Project	IEEE 802.16 Broadband Wireless Access Working Group < http://ieee802.org/16 >	
Title	A New Primitive for Indicating Network Attachment	
Date Submitted	2006-11-06	
Source(s)	Jaesun Cha and Chulsik Yoon	jscha@etri.re.kr
	ETRI 161 Gajeong-dong, Yuseong-gu Daejeon 305-700 Korea	
Re:	Contribution on comments to IEEE 802.16g/D5	
Abstract	In this contribution, we propose a new primitive to infer NCMS of network attachment.	
Purpose	Adoption	
Notice	This document has been prepared to assist IEEE 802.16. It is offered as a basis for discussion and is not binding on the contributing individual(s) or organization(s). The material in this document is subject to change in form and content after further study. The contributor(s) reserve(s) the right to add, amend or withdraw material contained herein.	
Release	The contributor grants a free, irrevocable license to the IEEE to incorporate text contained in this contribution, and any modifications thereof, in the creation of an IEEE Standards publication; to copyright in the IEEE's name any IEEE Standards publication even though it may include portions of this contribution; and at the IEEE's sole discretion to permit others to reproduce in

Figure xxx – network attachment

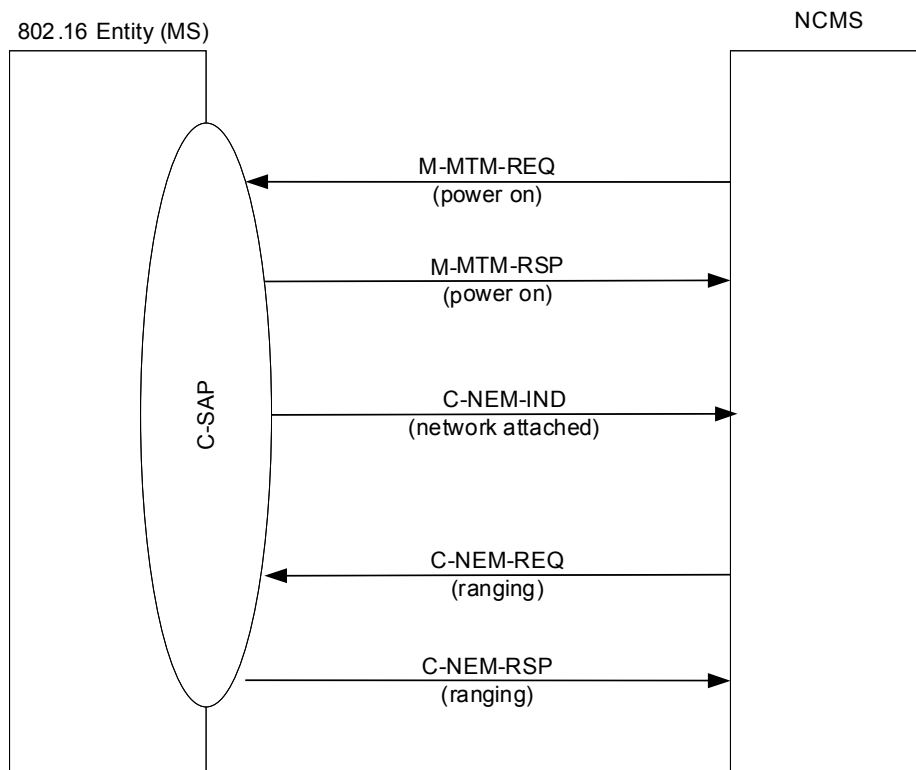
According to the current draft, NCMS shall issue M-MTM-REQ(power on) and C-NEM-REQ(ranging) primitives to activate 802.16 terminal. But, NCMS doesn't know when the 802.16 terminal is ready to perform ranging after it receives M-MTM-RSP(power on) primitive. After the 802.16 terminal is powered on, it shall scan for downlink channel, establish synchronization with a BS and obtain transmit parameters from UCD and DCD message before initial ranging. It will take a couple of seconds to complete aforementioned initialization steps because of transmission interval of UCD and DCD. Therefore NCMS can't issue C-NEM-REQ(ranging) right after it receive M-MTM-RSP(power on).

In this contribution, we propose a new control primitive which tell that 802.16 terminal is synchronized with BS and ready to perform initial ranging.

[Insert the following figure before subclause 14.2.81 on page 99]
